SMD Commissioning Offline Analysis Suggestions

RIKEN/RBRC Itaru Nakagawa

- Run#40562
- April 27, 2024 14:40 ~ 15:25?
- Trigger: ~450Hz @ ZDCNS Coincidence (after ZDC HV and threshould tune).

Figure 5.5: Eq. 5.2 fitting result of a strip.

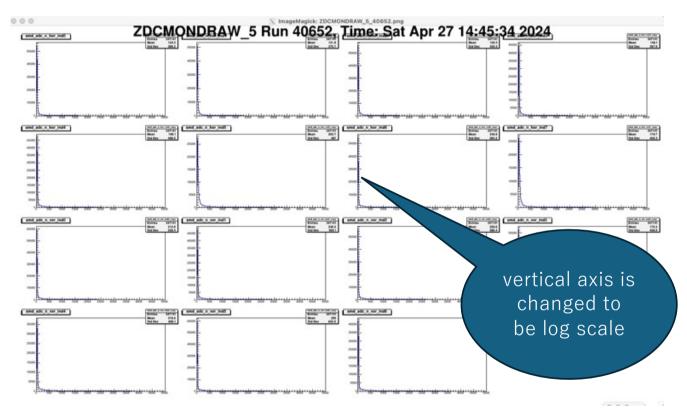
↑ This is how SMD ADC spectrum looks like in p+p. Please confirm if the right plot becomes like above once vertical axis is give in log scale.

x,y position Reconstruction

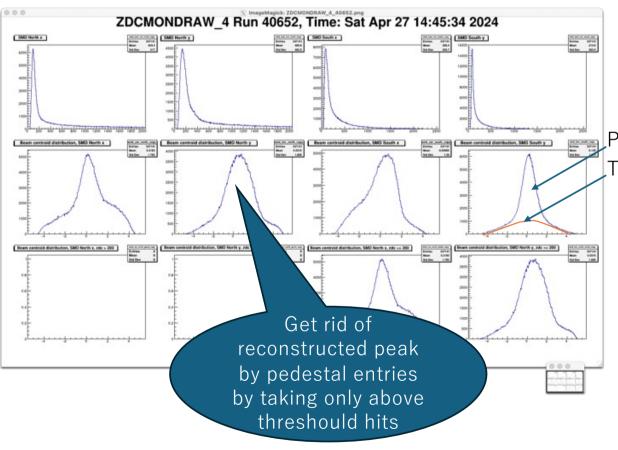
- Reconstructed x,y distribution seem to have two components.
- They look the superposition of pure pedestal narrower and true neutron peaks.
- The broader peaks may be the true neutrons since it shows symmetric in y-direction and leftright asymmetric in x-direction.

We should apply pedestal cut on SMD ADCs and use only hits above the threshould for all SMD paddles and get rid of reconstructed peak by pedestals.

Hit Multiplicity

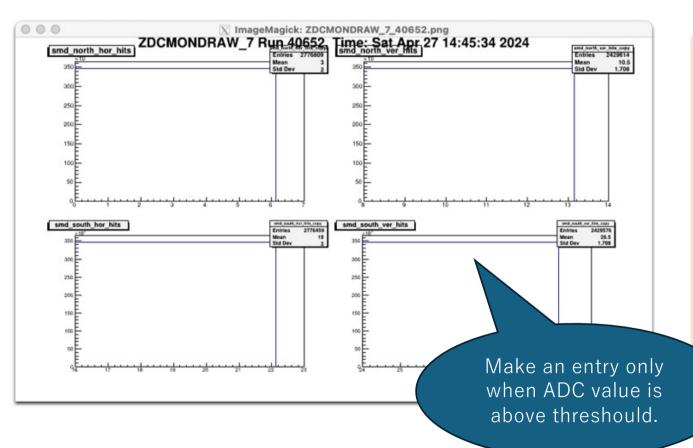
- Somehow the distribution is just flat.
- This is probably because hits are counted for every events. Each counter has at least finite pedestal, thus all paddles ends up with same entry.
- We should fill the histogram only when ADC value is above threshould.
- The distribution is expected to be peaked around center.

ZDCMONDRAW_1 Run 40652, Time: Sat Apr 27 14:45:34 2024

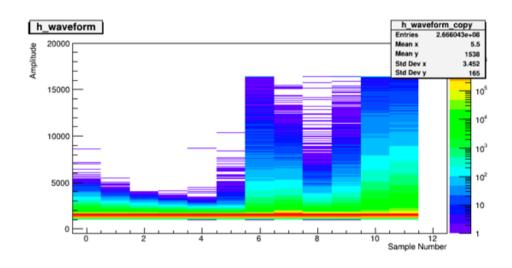
I am not sure if the ADC timing is correctly tuned at this moment.
